Product Change Notification: PCN-23-165658

RYII series relay - Cover material change

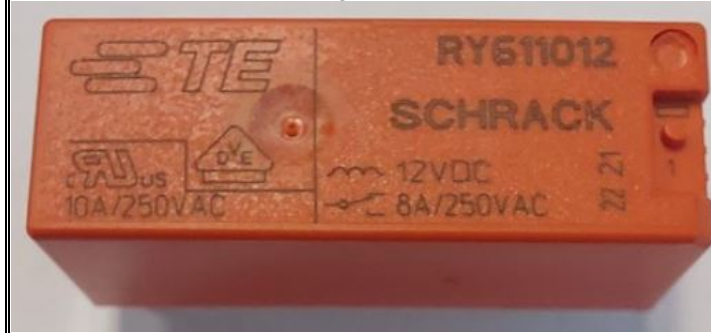
Dear customer, we would like to update the original PCN-22-152831. As all product tests (Contact compatibility, Thermal endurance, Sealing, PTI, GWT, Ball test, Electrical endurance) and certifications (UL, VDE, CQC, HazLoc) have been completed, We want to change the First Ship Date to February 20, 2023. The Relay form (dimensions), features and ratings keep unchanged. The original material can still be used as an alternative material.

The cover material before the change

The cover material after the change
